ML 2M LOUDSPEAKER SYSTEM

SERVICE INFORMATION

SERVICE BULLETIN

REPLACEMENT OF 8" LOUDSPEAKER 036-002

CROSSOVER NETWORK

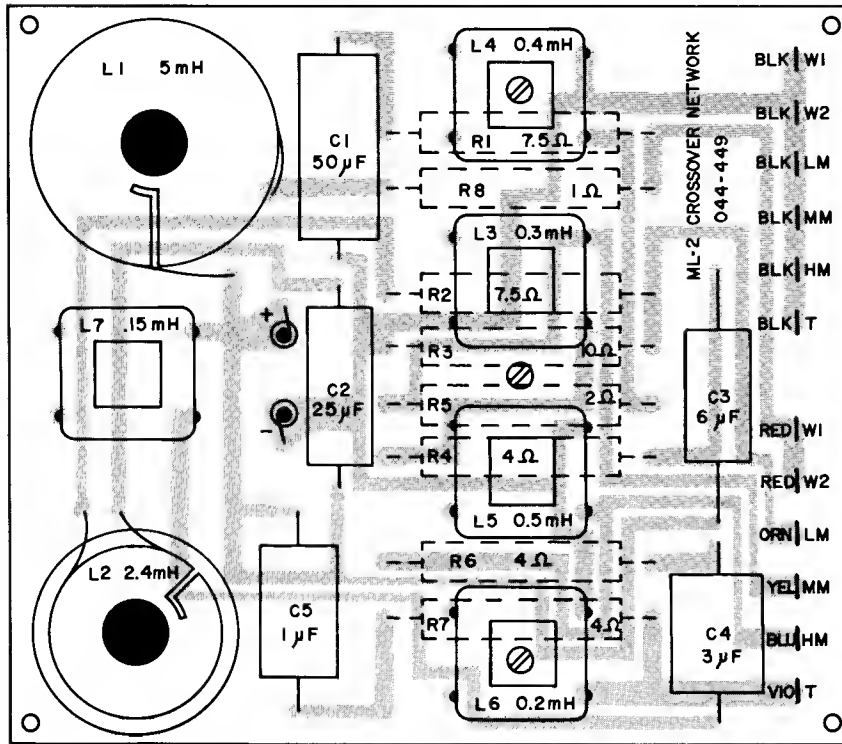
MODEL: ML-2C and ML-2M Loudspeakers.

PURPOSE OF MODIFICATION: To maintain the same acoustic output.

WHAT UNITS ARE AFFECTED: ML-2C Serial No. L1C001 through L1C429.
ML-2M Serial No. L1D001 through L1D145.

WHEN MODIFICATION SHOULD BE MADE: When replacing defective 036-002 8" loudspeaker.

- Step 1 Remove rear panel.
- Step 2 Locate 10Ω, 10 watt resistor in series with the 8" loudspeaker. Remove and replace with 7.5Ω, 10 watt resistor.
- Step 3 Replace rear panel.

SYSTEM SCHEMATIC

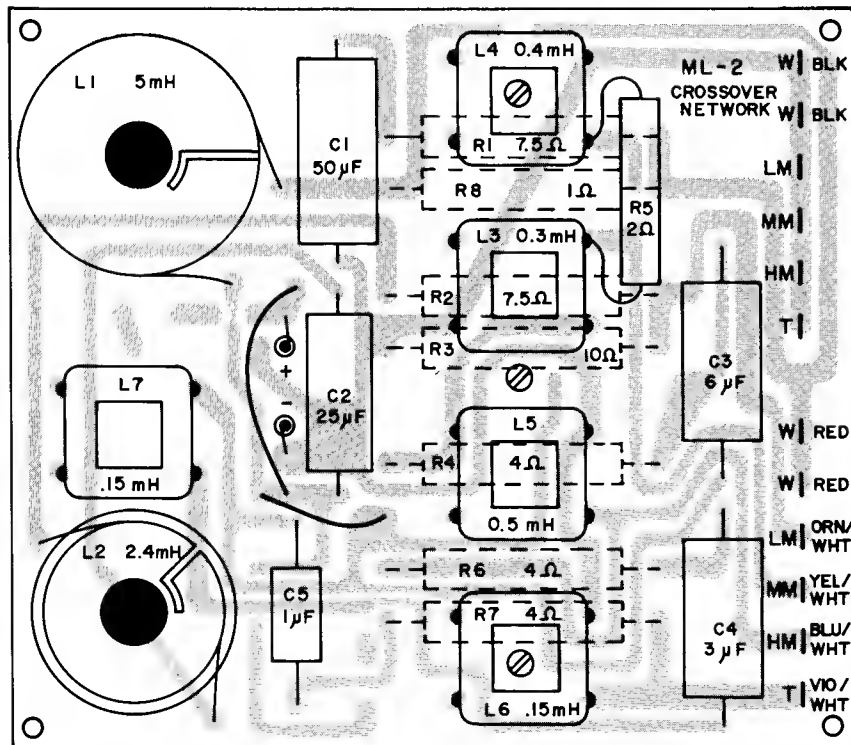
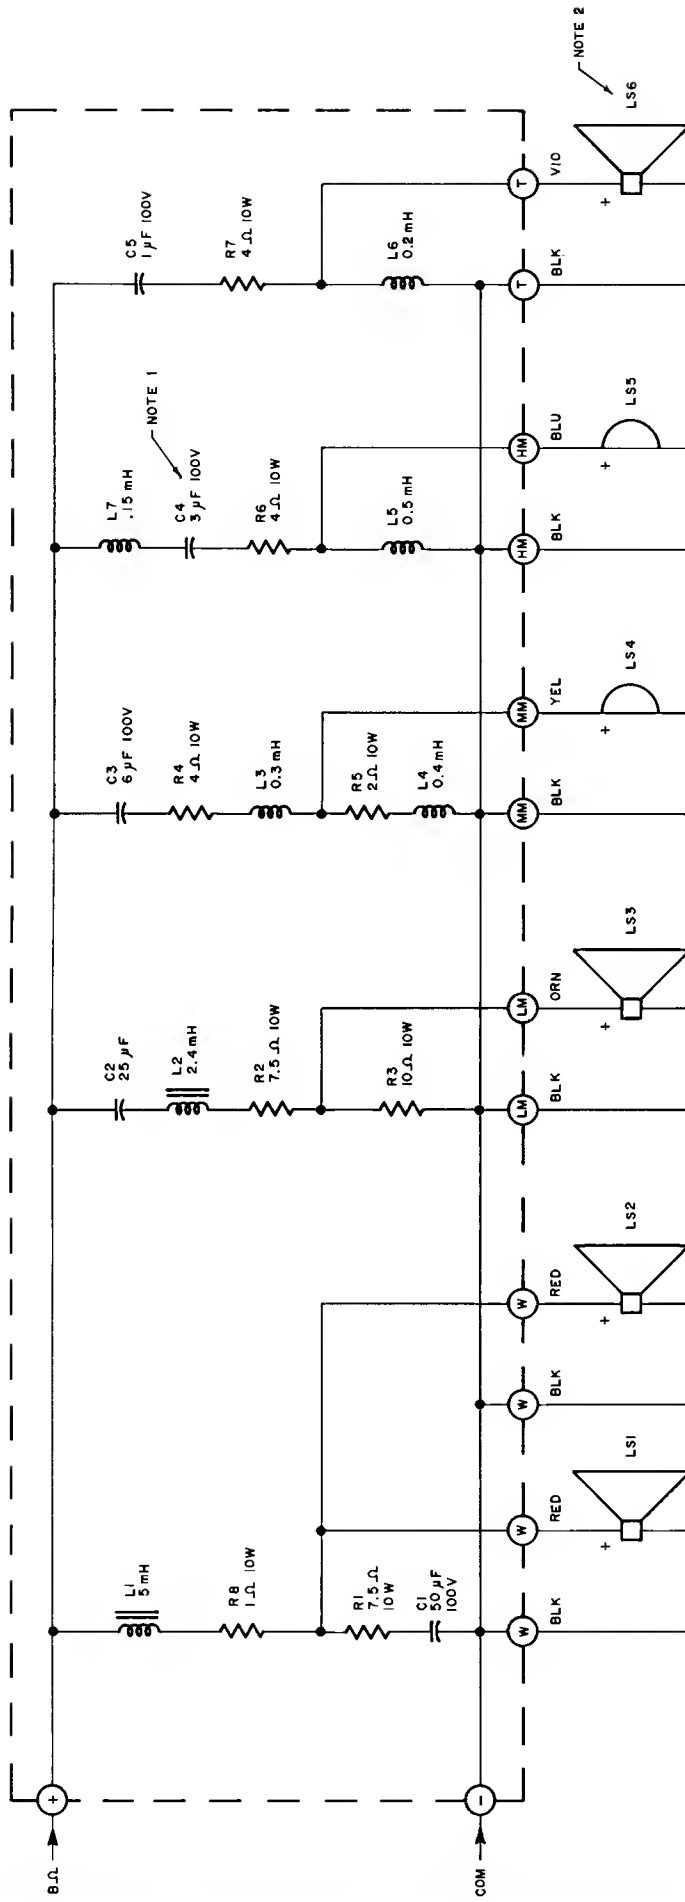
1. In early units C4 is 3.3 μ F.
2. In early units LS6 is 036-005 16 Ω impedance. LS6 can be replaced with 036-012 8 Ω impedance. Acoustic output will be the same.
